1.1 Density (Housing)

Extract from Planning Application by Hawkins Brown Architects

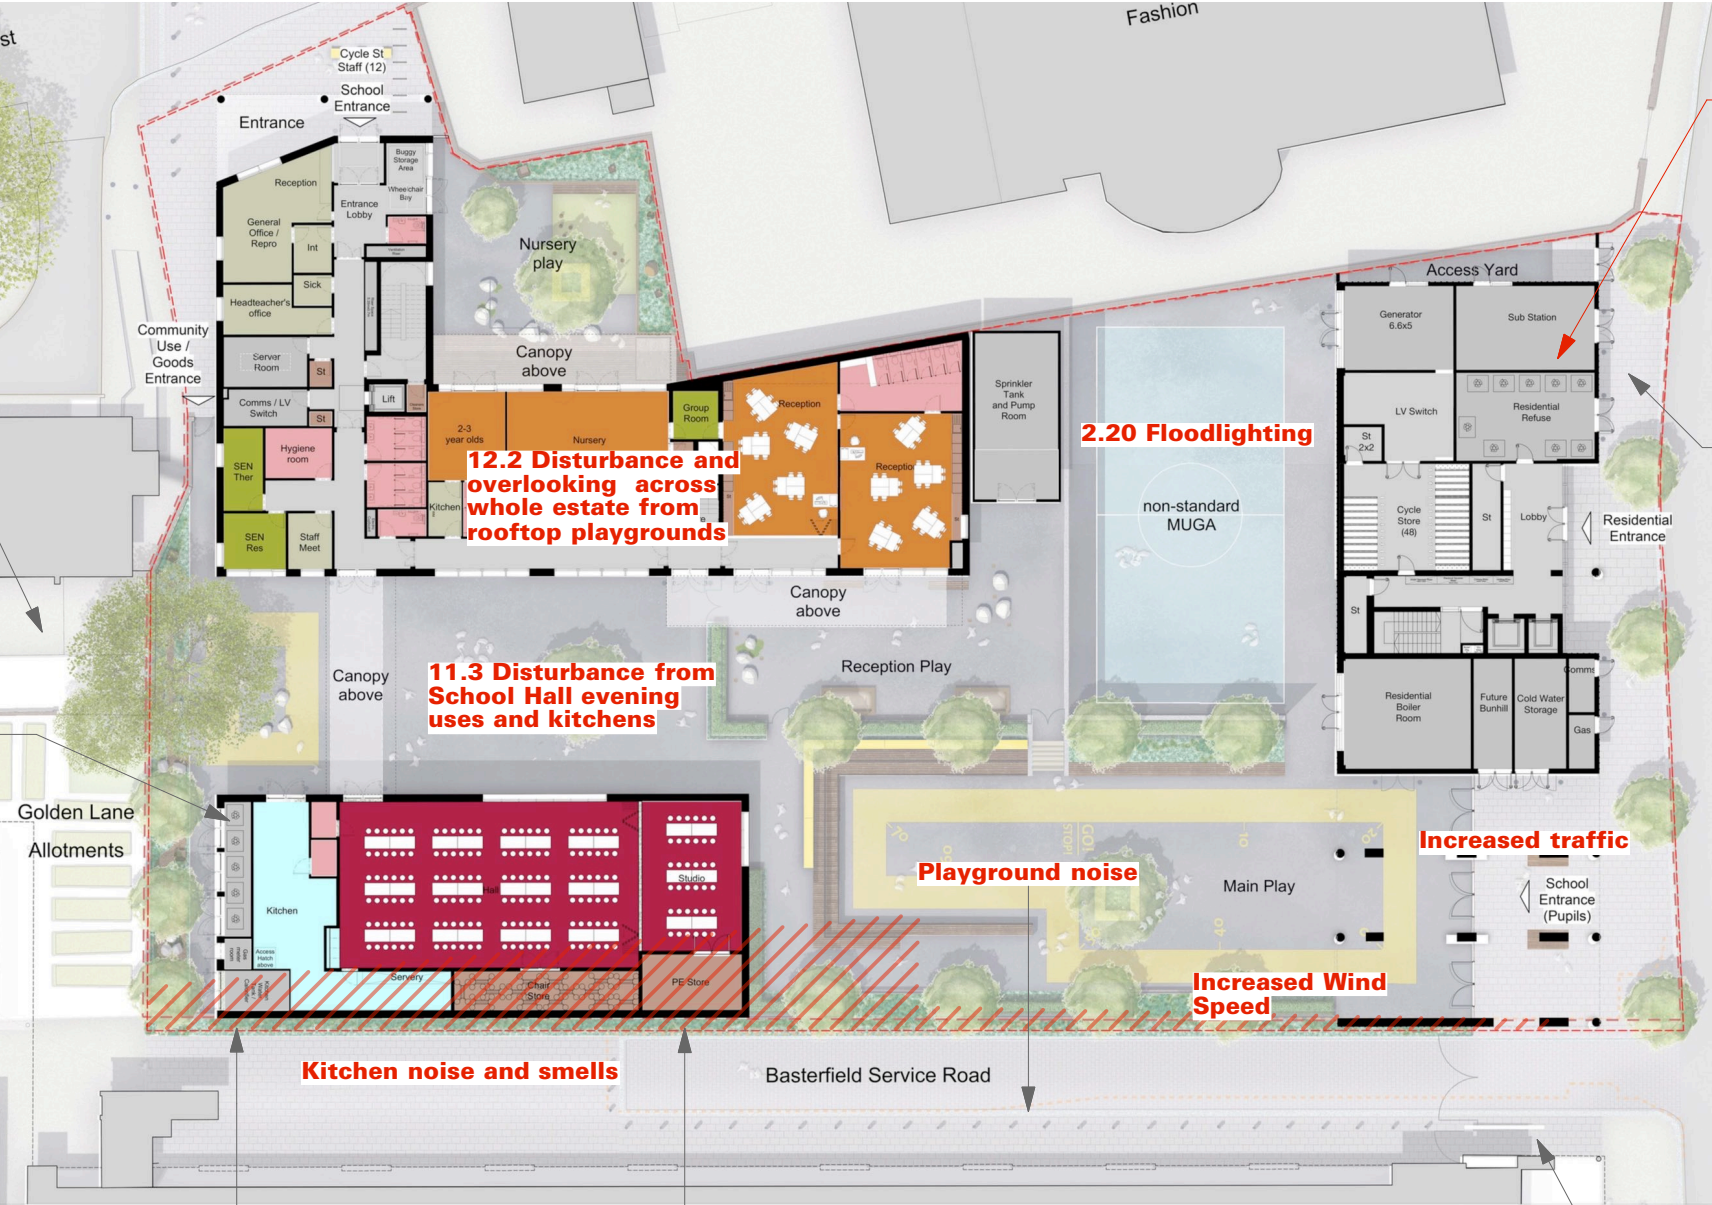
Proposed Density: 2436 hr/ha. 930 u/ha
London Plan Max: 1100 hr/ha, 405 u/ha

The density is 2.3 times the maximum anticipated density in the London Plan and five times the density of the original estate.

This site footprint should have no more than 78 habitable rooms/ 29 Units.

1.3 Density (School): School population increasing from 80 pupils to 458. (2 Form Entry) No demand in Finsbury or CoL. Moreland School opened at half capacity and spare capacity at Moreland will be sufficient until 2029.

2.5 Award-winning Golden Lane Allotments shaded by new double height Hall in mornings

2.7 Mature trees lost along boundary

2.11 School Hall should be part of School Building. Location of proposed Hall less than 3m from Basterfield House and affecting design of listed Estate

1.23 The School bin stores are inadequate when compared to Prior Weston

2.2 Curtilage: Part of listed curtilage of GLE incorporated into school site (shown in red hatch). Amenity space and disabled garages lost without consultation with GLE Residents

56 Cycle Spaces Required
12 Cycle Spaces only Provided

1.4 Views: New tower block visible across whole Estate in long views

1.30 Accessible Parking:
No wheelchair accessible parking being provided. 9 Spaces required
Two essential accessible parking garages being lost from Golden Lane Estate.

1.26 Views: Finsbury Local Plan BC9 states that development shall "Enhance the quality of street-level and long-distance views, including across borough boundaries"

Excessive number of housing units proposed. School is proposed as two form entry even though no demand has been demonstrated in Islington's own study. Even the School Hall is oversized.

Resulting in massive over-development of site - no amenity space and and pressure on Golden Lane Estate

5.1 Height: Finsbury Local Plan shows this area as suitable for 4-6 storeys, not 14 storeys. Islington Development Management Policy DM2.1C: "The only locations in Islington where tall buildings may be suitable are set out in the Finsbury Local Plan (Area Action Plan for Bunhill and Clerkenwell)."

10.5 Access to Nature: Finsbury Local Plan calls for public access to nature for this site to ease the pressure on Fortune Street Park

We think School Hall should be moved here, and this is why:

- Entrance off Golden Lane for After Hours events
- Direct connection to School - kids don't have to cross playground
- Playground supervision easier
- Not in middle of GLE
- Causes less disturbance; does not block views of listed estate
- Same massing as existing RCS so no planning issues

5.7 Blank Facade: New tower block has 50% "blank" facade at Ground Level. Security problem and old fashioned design. Plant and boilers at ground floor level should be moved into basement.

2.24 Overlooking: Balconies and South facing windows in new tower directly overlook Basterfield House with no screening

1.9 Play Space: London Plan, Policy 3.6:
The new housing is expected to yield:
Under 5: 27 Children
5-11: 11 Children
12+: 6 Children
= **430 sqm of children's play space** for the residential

Residential Provision:
99 Cycle Spaces Required
48 Cycle spaces only provided

1.8 No Public Open Space to be provided under the scheme. Contrary to *The City of London Open Space Strategy SPD*. Further, approx 275 sqm of amenity space and publicly accessible open land currently part of Golden Lane Estate and the CoLAEC is to be removed by the application.

2.32 Entrance Alterations: Pavement is to be narrowed and wall placed directly in front of Basterfield Entrance

2.12 Noise and smells from school Kitchens. Windows of Basterfield single glazed with permanent vents, Cannot be closed off.

2.11 Sports Hall is 4.5m high internally. Sports England advise 3.5m height Reduce height of Hall and relocate

2.16 Noise from school playgrounds very close to single glazed rooms of Basterfield House. Scheme needs to contribute to double glazing Basterfield windows under Section 106 agreement

2.22 Daylight levels will be negatively impacted by proposed scheme. Reductions are significantly worse than BRE guidelines permit.

Altogether **122 windows** in adjacent buildings will be impacted beyond BRE guidelines.

Some rooms are **losing 60-70% of their access to natural light.**
